WATEROUS

Technical Bulletin No. 140

Anode Update

Old Anode (Zinc)

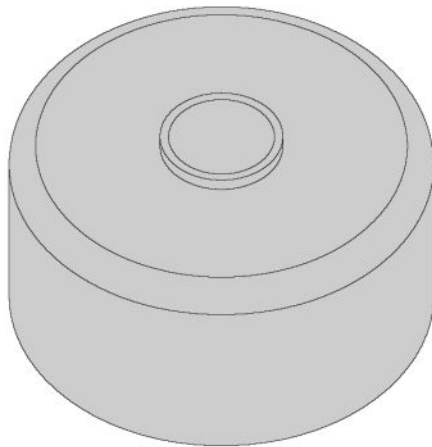
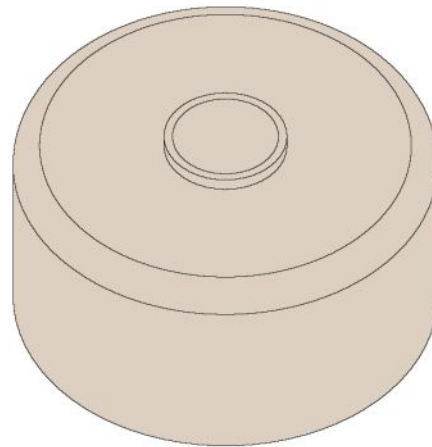
In 2020, the optional zinc anode was replaced by an interchangeable magnesium anode. The anodes share the same dimensions, but magnesium was found to be more efficient in preventing pump corrosion in fresh water applications.
